Work Order ID 162226

Item Name: Replacement Skidtube (Fits LH or RH)

DRAWING NO. D2650	TITLE 206/407 SKIDTUBE ASSEMBLIES	REV. F	DART AEROSPACE LTD ENGINEERING ORDER		D.E.O. NO. D2650-F-1	SHEET NO. SHEET 1 OF 1	SCALE NTS
DRAWN <i>JP</i>	CHECKED <i>A.P.</i>	MFG. APPR. <i>DA</i>	APPROVED <i>TH</i>		DE APPR. <i>TH</i>		
DATE 12.10.12	DATE 12.10.22	DATE 12.10.22	DATE 12.10.22		DATE 12.10.22

CHANGE C'BORED WELDED CROSSBOLT SPACERS TO SWAGED SPACERS

ADD DETAIL G BELOW, WHICH IS THE SAME SECTION VIEW AS DETAIL D OF DWG.

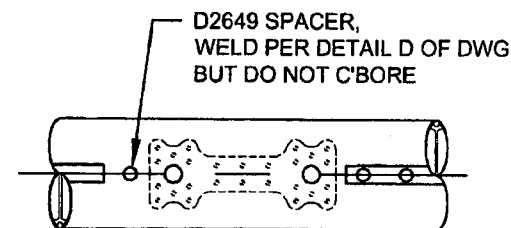
PARTS LIST IS AMENDED AS FOLLOWS:

QTY	QTY	QTY	QTY	PART NUMBER	DESCRIPTION
-1	-3	-5	-7		
1	1	0	0	D2649	CROSS BOLT SPACER
16	17	19	23	D4720-1	SPACER

17	18	19	23	D2649	CROSS BOLT SPACER
----	----	----	----	-------	-------------------

C'BORED HOLES ARE NOW SWAGED PER DETAIL G BELOW. FOR THE Ø0.375 HOLE THAT IS NOT C'BORED, WELD PER DETAIL D OF DWG (SEE AMENDED DETAIL B FOR REFERENCE).
